CMD : 20-M13.A

Approve Regulatory Documents

Submitted by:
CNSC Staff

Figure 1: Site characterization in the CNSC regulatory process

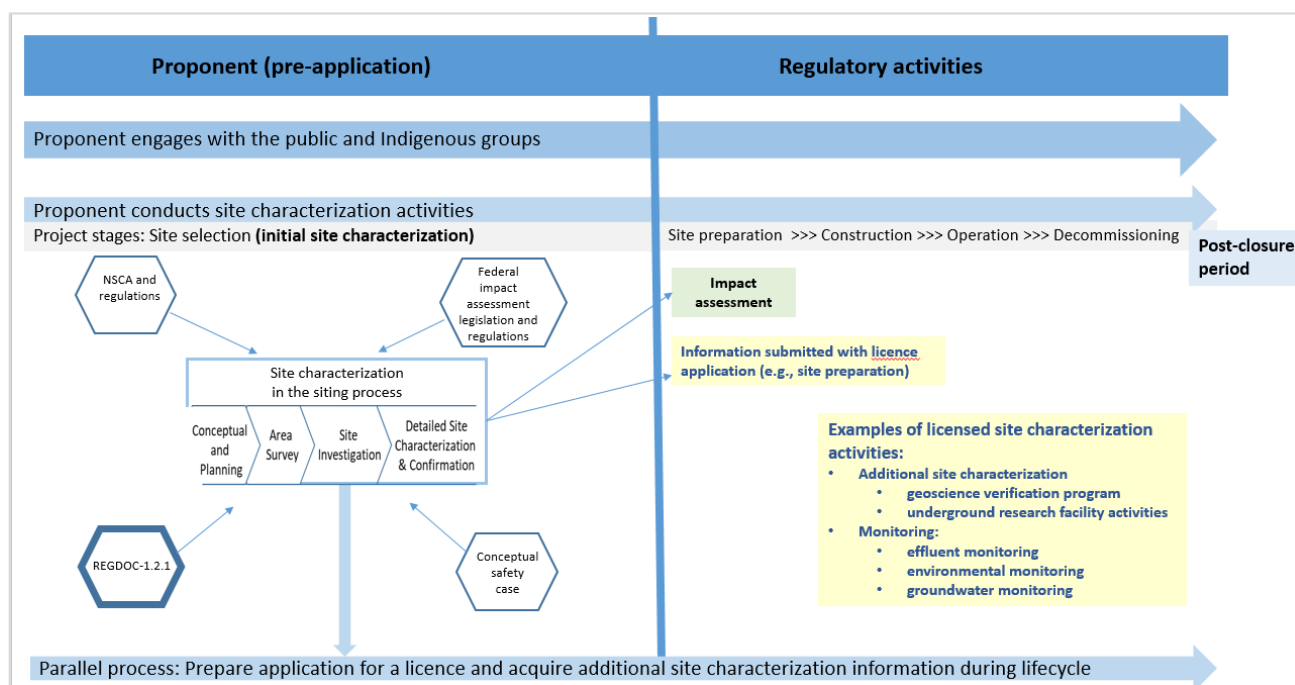
222.	Section 3.1, Figure 1 and Appendix A, Section 4	Bruce Power, BWXT, Cameco, CNA, CNL, CANDU Owners Group, Hydro-Québec, Kinetrics, NB Power, NWMO, OPG, Orano	<p>MAJOR The REGDOC should be clear that the level of detail and information supporting a given licence progressively increases with each licensing phase. It should not suggest that the same requirements apply to different licences. For example, there would be more information/evidence available from site characterization to support a construction licence application than a licence to prepare site application (which could be requested earlier).</p> <p>Suggested change: Similar to the Class I regulations, Section 3.1, Figure 1 and Appendix A, Section 4 should be clear that there are different requirements that apply depending on the licence being considered. The initial licence application referred to in the last sentence of Appendix A, Section 4 will be very different if the</p>	<p>There are no requirements in this document. The revised document was carefully evaluated for consistency with the NSCA and associated Class I regulations.</p> <p>Revisions to the document were undertaken to provide clarity. This was done by addressing and incorporating comments from industry, civil society organizations, and other stakeholders. The revision and drafting of Section 3, 3.1 and Figure 1 in REGDOC-1.2.1, <i>Guidance on Deep Geological Repository Site Characterization</i> addressed many of those comments.</p> <p>Requirements for a post-closure safety case (including safety assessment) are not addressed or defined in this document (section 1.2, bullet 5). Similarly, safety analysis is not referenced in this document, except to say that it is not within the scope of the document (section 1.2 bullet 4). Section 1.2 (scope) in the revised REGDOC indicates that these topics are addressed in REGDOC-2.11.1, <i>Waste Management, Volume III: Safety Case for Disposal</i></p>

74.	3.2.3	Northwatch	The document should clearly set out the basis for evaluation of the information to be collected, including that identified for collection and evaluation in Section 3.2.3	Comment noted. CNSC staff will evaluate this data if submitted as part of a licence application. This is generally depicted in Figure 1 in the revised REGDOC-1.2.1.

115.	1	Saint John Citizens Coalition for Clean Air	<p>I fully concur with NB Power's first comment in respect to this issue of using words such as may that is unclear in terms of CNSC's requirements expected of licensee's.</p>	<p>This document provides guidance on activities that would be begin in a pre-licencing period, and thus not be regulated under the NSCA. However, the data gathered during this time would be evaluated by CNSC staff should a licence application be submitted. Please see Figure 1 in the revised document.</p>

<p>“This information would be submitted with a licence application and feed into any environmental assessment.”</p> <p>This information is also illustrated in Figure 1 in the revised document.</p>
